ARMSTRONG SPALLUMCHEEN PARKS & RECREATION

REQUEST FOR PROPOSALS (RFP) - Addendum No. 3

Make-Up Air Unit Hassen Arena - ASPR-2026-002

Addendum Issue Date: August 28, 2026

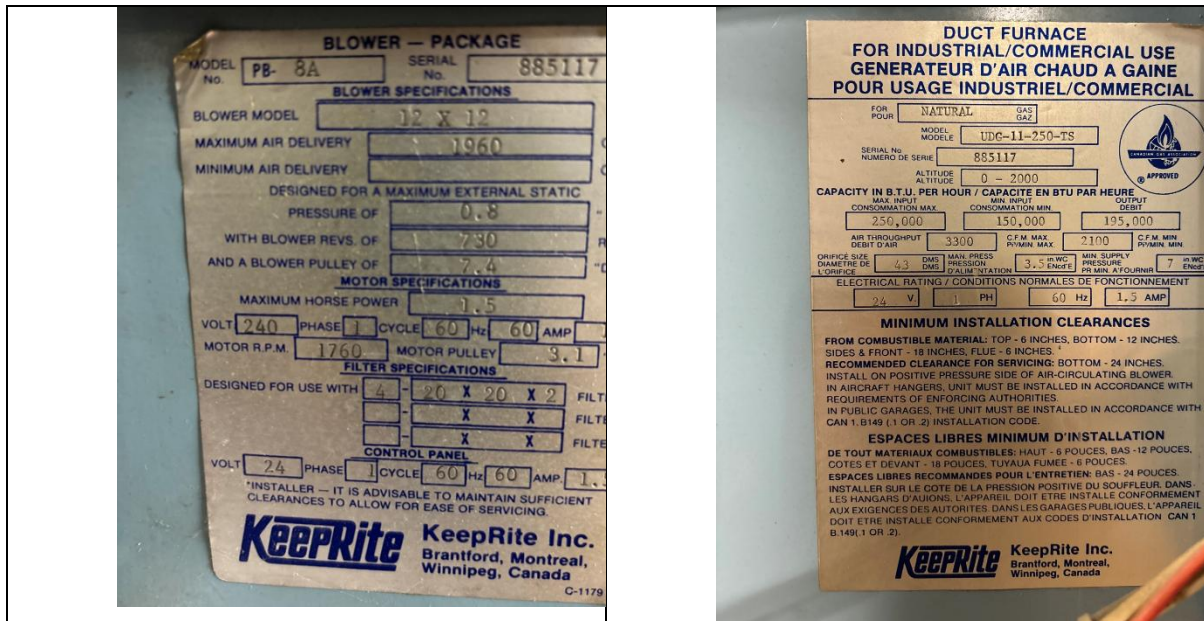
13. Please confirm the correct make/model of the existing MUA. Addendum No. 2 lists model "UDG-11-250-TS," while Inland Technical's Air Moving Equipment Test Sheet (Oct 23, 2024) lists "Keep-Rite PB-8A," both under serial #885117.

Response: The references are two separate pieces of equipment associated with the existing make-up air system:

- Furnace – UDG-11-250-TS
- Blower Motor – PB-8A

Photos provided for reference:
